**FINAL
ENVIRONMENTAL IMPACT STATEMENT**

**Continued Operation of K-, L-, and P-Reactors
Savannah River Site
Aiken, South Carolina**

U.S. Department of Energy

TC [DOE has revised the Draft EIS, as appropriate, in response to the comments
received in letters and during three public hearings (May 31, June 5, and June
8, 1990) from individuals, organizations, and Federal and state agencies.
These revisions are indicated in the Final EIS by vertical change bars in the
margin. Most of these change bars are marked either TC (technical change) or

Figure 2-9. Operating Contractor Reactor Shift Organization.

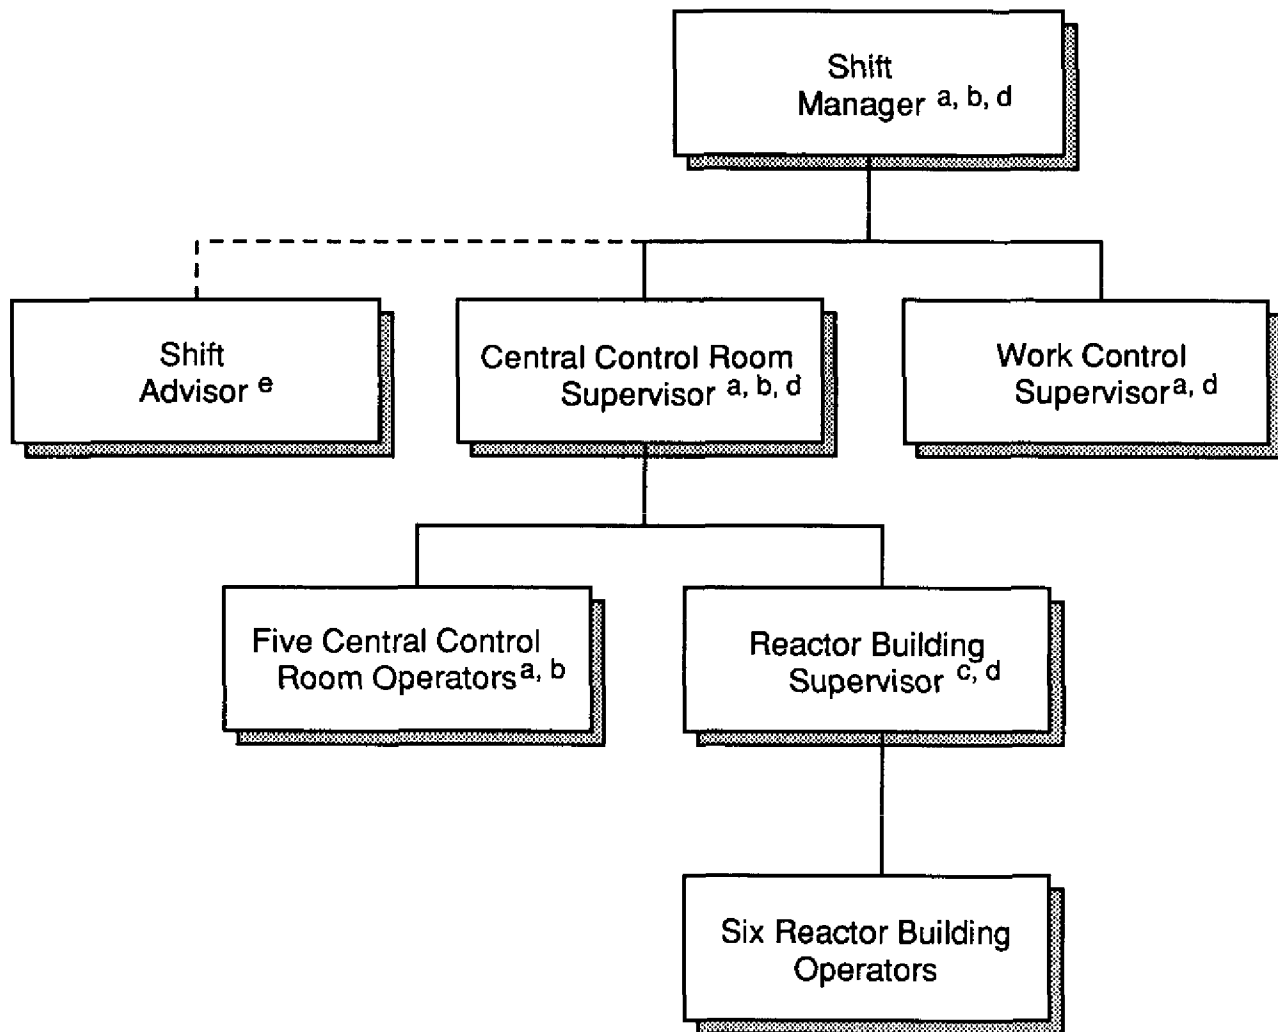
10. DOE STAFFING	
L-66-22	Page 2-44 states that DOE hopes to provide four Area Engineers for each reactor area. No statement about the number of personnel to be present prior to restart is made. The final EIS should specify the number of DOE Area Engineers required prior to restart of any given reactor. In the absence of this information, it is logical to require four engineers per area prior to restart — which seems not to be the case at present.	DOE has revised Section 2.1.2.8.1 and Figure 2-9 to discuss the reactor shift personnel complement.

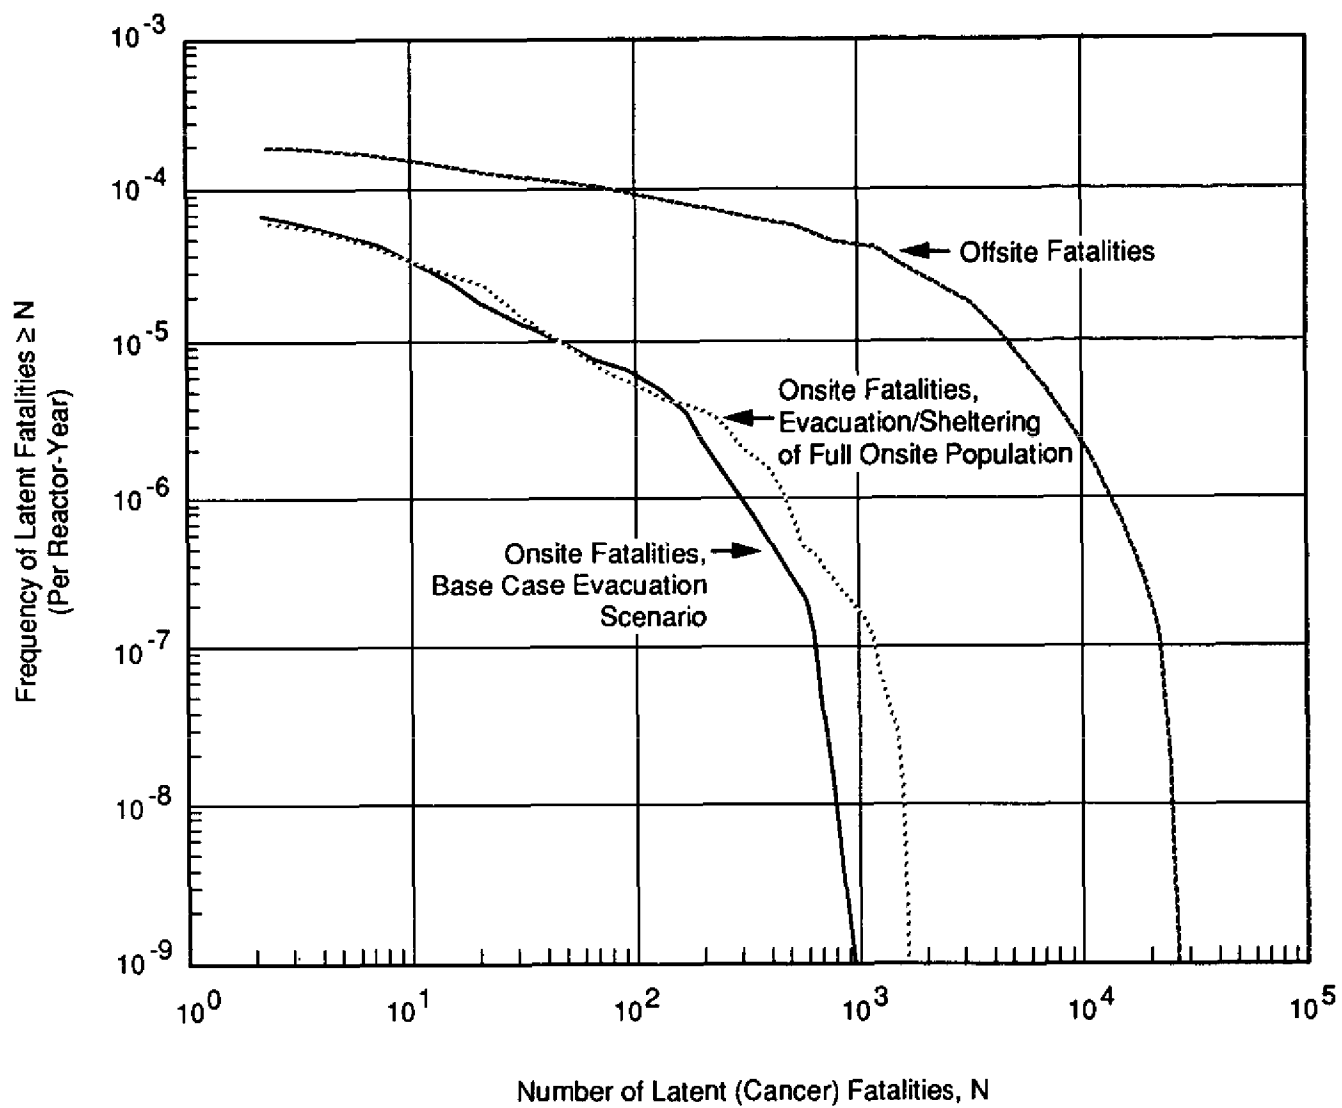
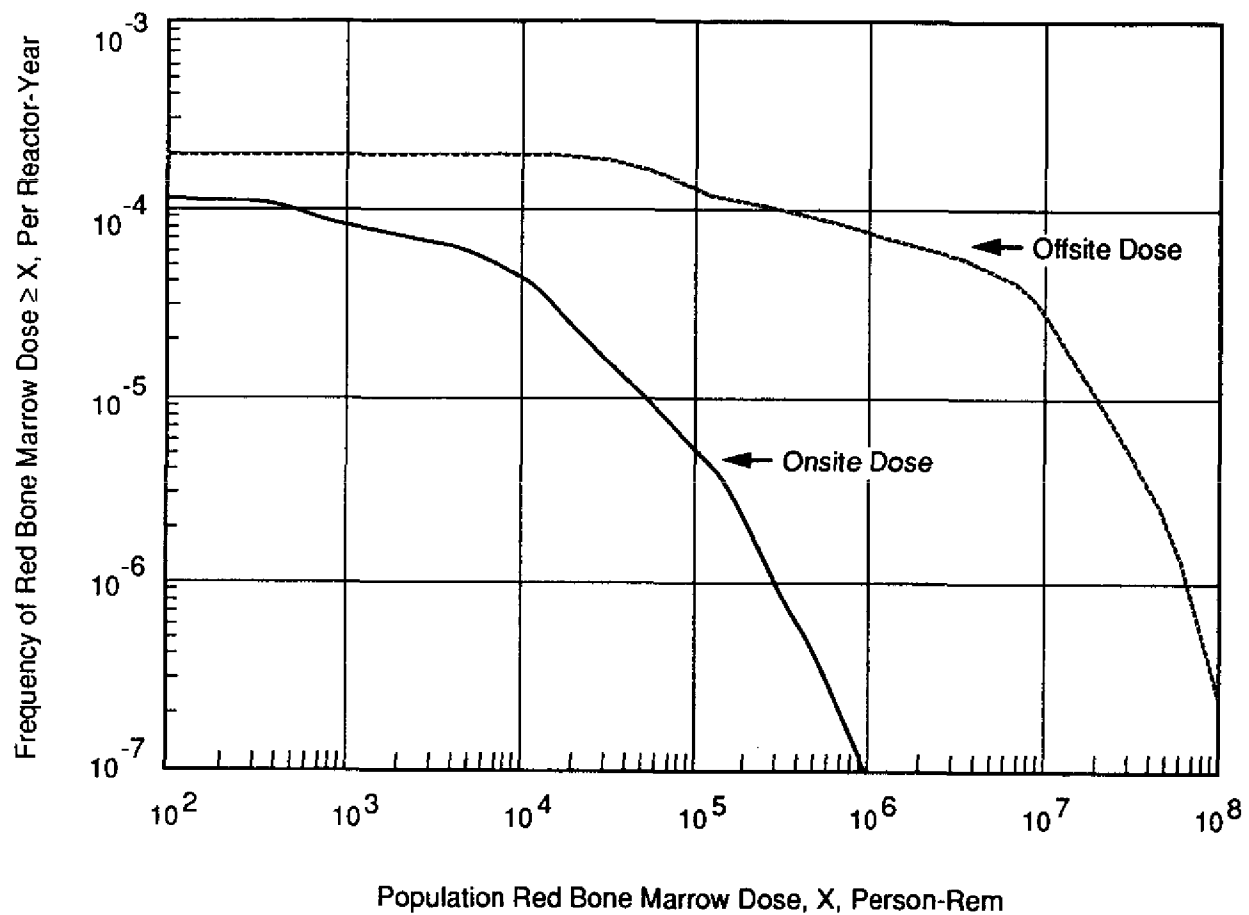
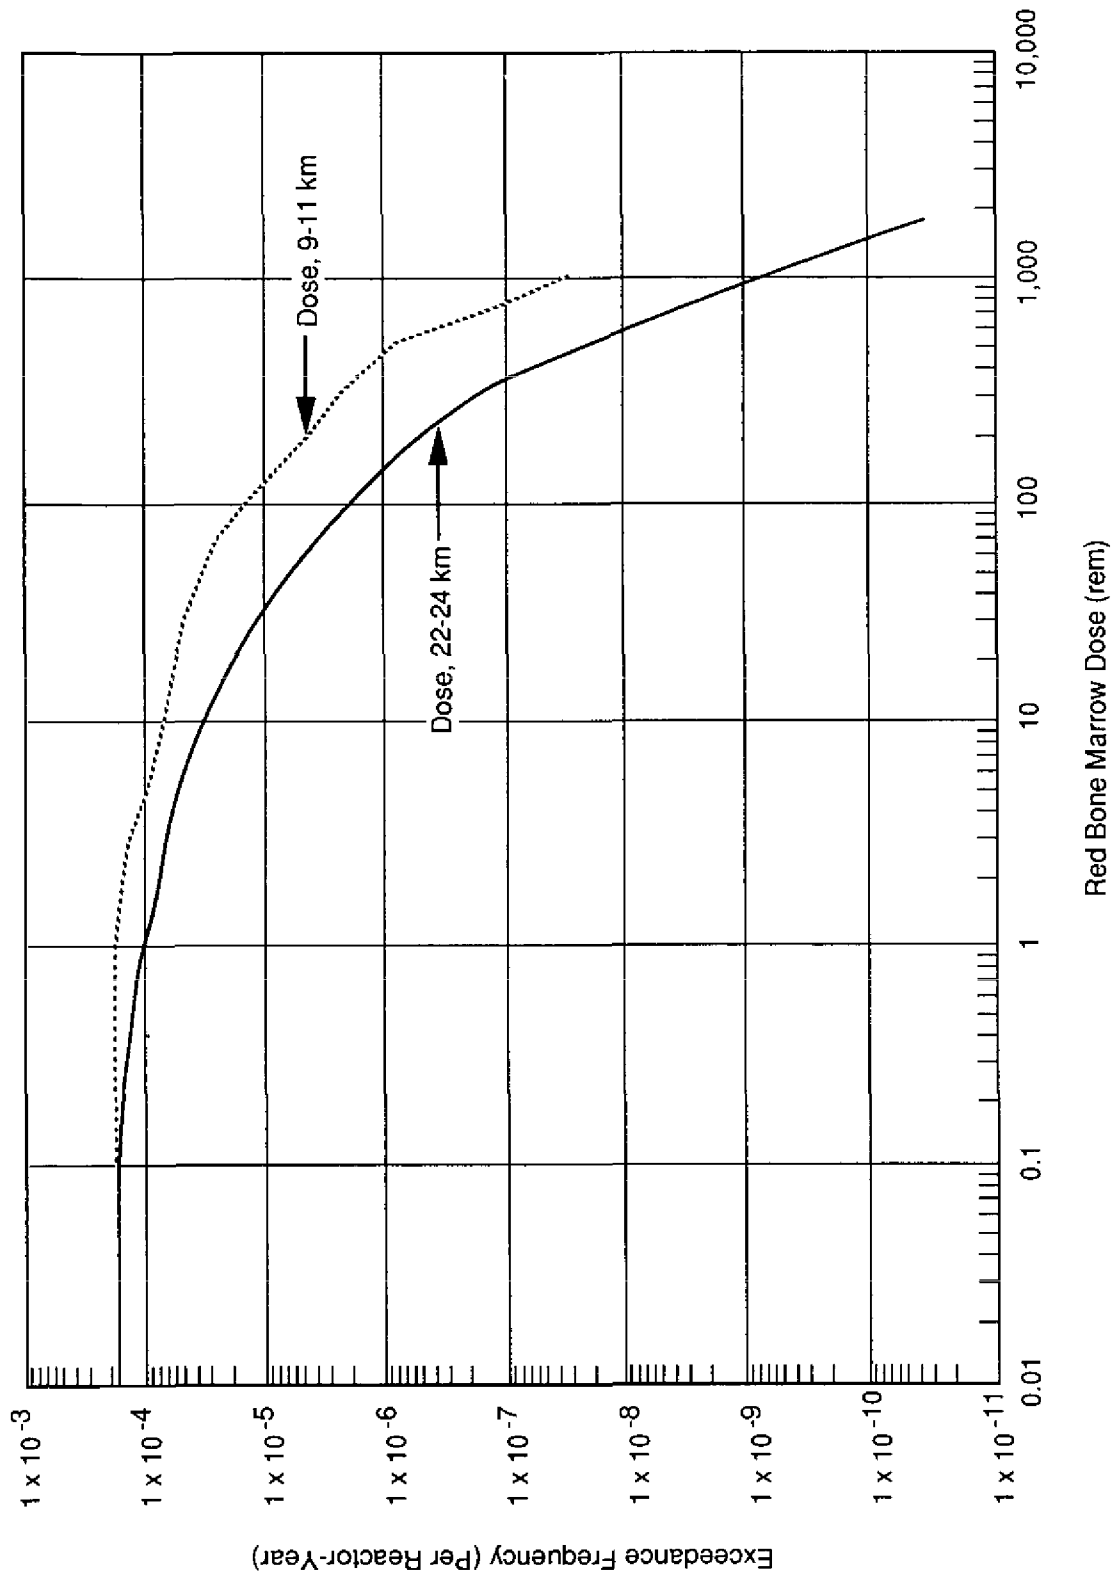
<u>Consequence Analysis</u>		
L-75-13	The only consequences which are quantified in the DEIS are prompt (early) fatalities, latent cancer fatalities, and population bone marrow dose (DEIS, Figures 4-7, 4-8, and 4-9). However, it is well known that the MACCS code performs a variety of other consequence calculations. The environmental impact of severe accidents is not limited to early and late fatalities and dose versus distance impacts, although these are potentially important measures of environmental impact. The final EIS should provide the	The MACCS will calculate such consequences as costs of intermediate relocation, farm product disposal, and land decontamination/interdiction costs; the inputs required to calculate these consequences are so subjective, and the algorithm used for the calculations is so rudimentary, that the outputs would not be particularly meaningful or defensible. Supporting studies for the EIS, including the Safety

Figure 4-8. Frequency of Latent (Cancer) Fatalities Due to Severe Accidents.

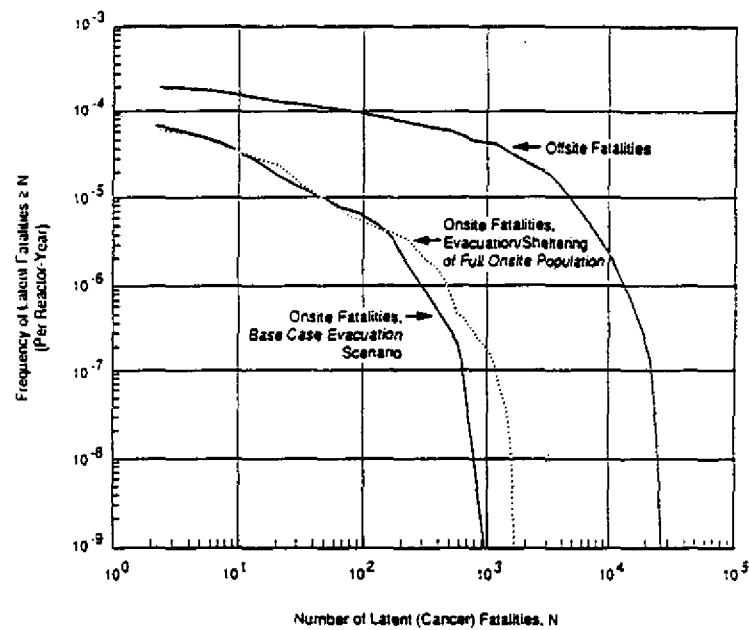
* Exhibit 2 shows a probability of about 10^{-4} per reactor-year that a reactor accident will lead to 100 or more offsite cancer fatalities; this implies that, if 3 reactors are run for 10 years, the probability of such an outcome will be 0.3%.	
L-44-19	* The type of presentation used in Exhibit 2 merges probabilities of a wide variety of types and does not show the many uncertainties involved; it is, therefore, misleading.	Combining probabilities of events of different types is a valid methodology; the individual event probabilities for all release categories are too voluminous to include in the EIS, but they are in the Safety Information Document which is referenced in the EIS as WSRC, 1990. Also, please see response to Comment L-44-17 on uncertainty.

Figure 8.9 Peach Bottom external events, core damage frequency ranges (5th and 95th percentiles).

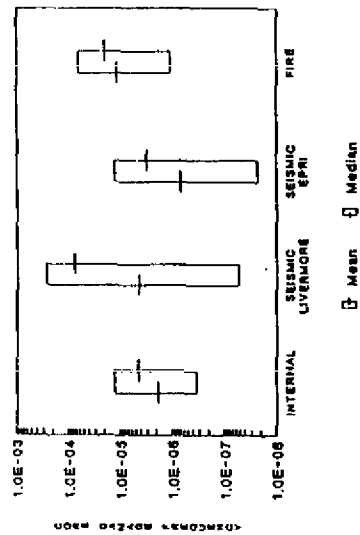
Comment Number	Comment	Response
L-44-20	* The draft EIS does not show an uncertainty range for its estimates of risk; Exhibit 4 illustrates this lack by showing the uncertainty range (itself questionable) in one estimate of core damage probability for the Peach Bottom commercial reactors.	DOE has rewritten Section 2.1.3.1.2 of the EIS to include the Level-1 PRA core damage frequencies and the range of uncertainty. DOE also has changed Section 4.1.3.1.5 to include a discussion on uncertainty.
L-44-21	* Accident consequence estimates presented in the draft EIS assume that people could be evacuated from within a 20-mile radius of the affected reactor, starting 2-4 hours after a release begins, with an average evacuation speed of 1-2.5 mph (see Table 4-33 of: DOE, 1990); however, there is no current planning for such an extensive evacuation (see the emergency planning discussion at pp. 3-61 to 3-65 of: DOE, 1990).	DOE disagrees that there are no plans for an evacuation as used in the consequence assessment. Current emergency planning consists not only of plans at SRS, but also planning by the States. The assumptions used for the consequence assessment represent a reasonable, yet conservative, set of parameters. DOE has changed Section 4.1.3.1.5 of the EIS to include a discussion of evacuation speed and distance assumptions.
